ORIGINATION FORM

Proposed Revisions to a Standard Plans Index
(Please provide all information — Incomplete forms will be returned)

Index Number: 509-100
Sheet Number (s): 1 of 1
Index Title: Advance Warning For R/R Crossing

ACTIVE STATE (TRAIN CIRCUIT ACTUATED)

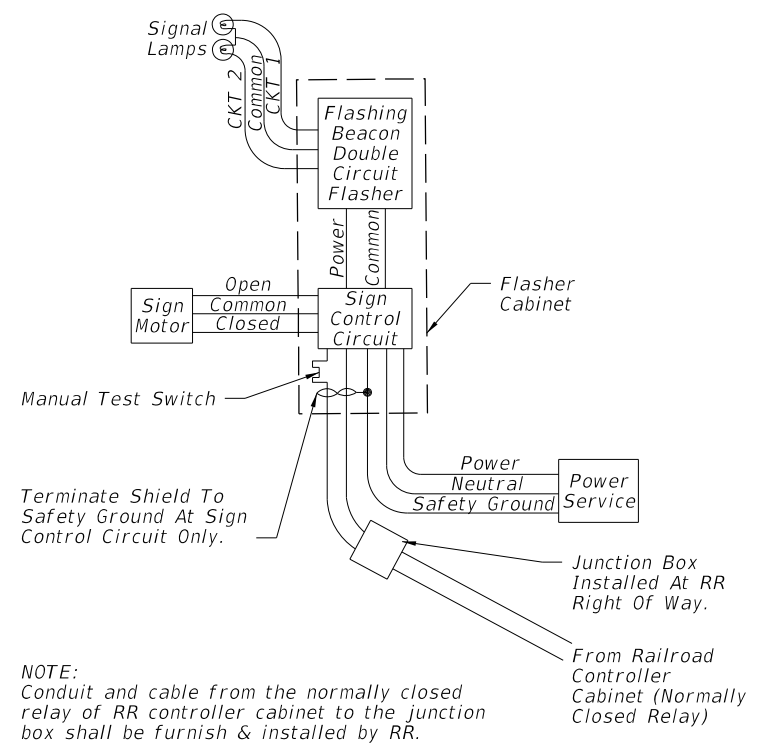
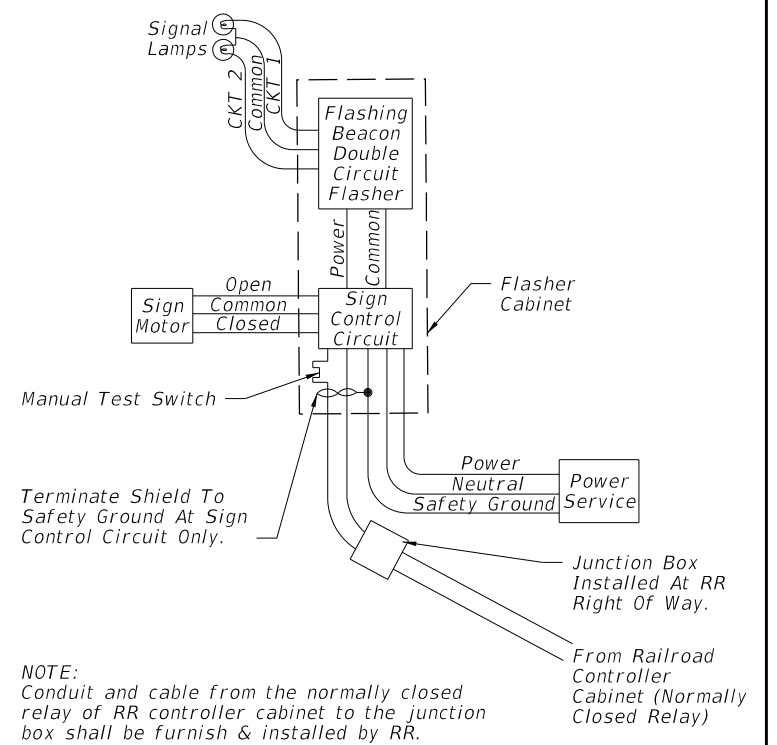
Sheet 1: Changed "Class I" to "Class II" in the Front View of the ACTIVE STATE Detail.

Changed to reflect Materials specification change that removes the designation for Class I Concrete.
Please see the attached Standard Specification Section 346 DRAFT for the Class I revisions proposed by the State Materials Office.

CHANGED TO: Class II
